**HISTORIC AND DESIGN REVIEW COMMISSION  
COMPLIANCE AND TECHNICAL ADVISORY BOARD**

**HDRC CASE NO:** 2024-036  
**ADDRESS:** 1120 IOWA ST  
**LEGAL DESCRIPTION:** NCB 3885 BLK 1 LOT 6  
**ZONING:** RM-4, H  
**CITY COUNCIL DIST.:** 2  
**DISTRICT:** Knob Hill Historic District  
**APPLICANT:** Michael San AntonioTexas/ELIZONDO MICHAEL & SANDRA  
**OWNER:** Michael San AntonioTexas/ELIZONDO MICHAEL & SANDRA  
**TYPE OF WORK:** Window replacement  
**APPLICATION RECEIVED:** January 18, 2024  
**60-DAY REVIEW:** March 18, 2024  
**CASE MANAGER:** Rachel Rettaliata

The applicant is requesting a Certificate of Appropriateness for approval to replace 7 existing wood windows with fully wood windows.

Window 1

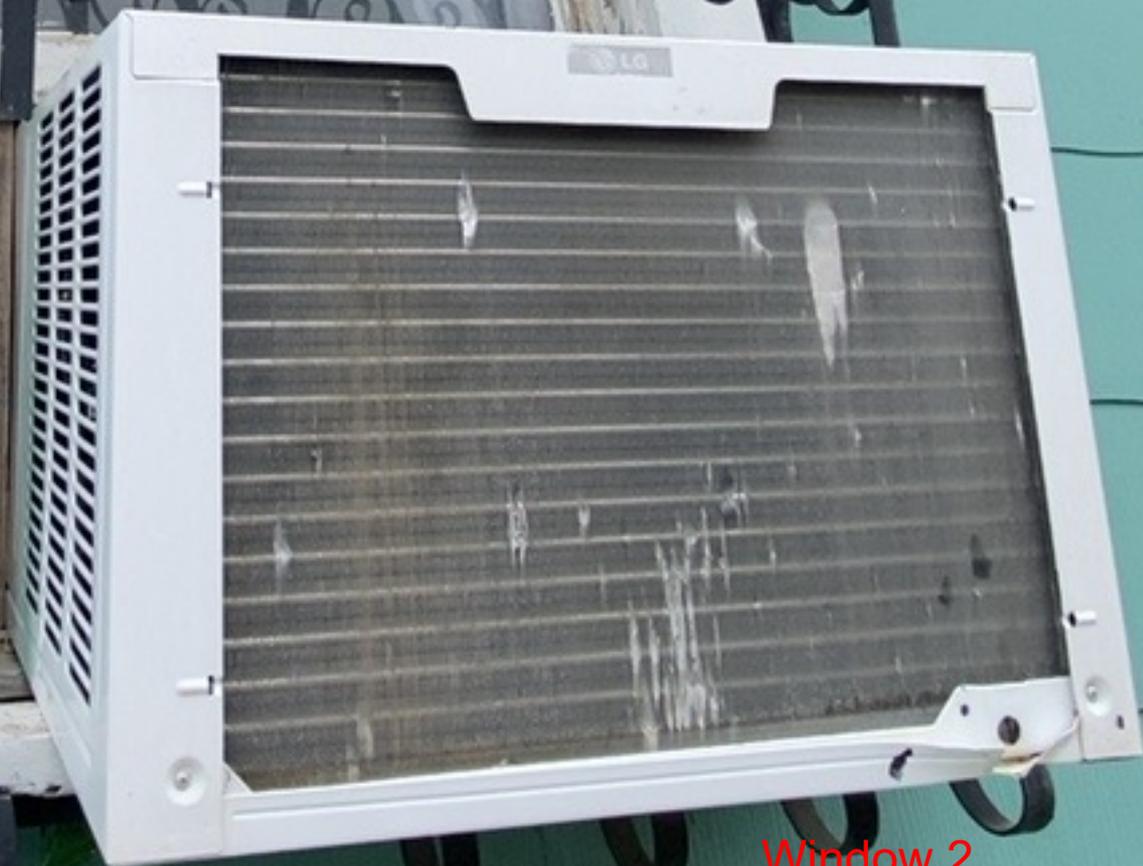
- b. WINDOW REPLACEMENT: EXISTING CONDITION – The applicant has requested to replace seven (7) existing wood windows with Pella fully wood windows. Staff conducted a site visit on February 15, 2024, and observed the following conditions on the remaining original wood windows: damaged and peeling or chipping paint, broke cords, and loose or missing glass, glass that has been inappropriately repaired, and sashes that are not secured in the framing. Some of the existing windows may require reglazing or the reworking of the sashes. The windows do not show signs of significant wood rot, wood damage, or severe deterioration. Staff finds that all remaining wood windows are in repairable condition, with most requiring minimal repair and intervention like re-glazing and painting, along with refitting into the trim and frames.
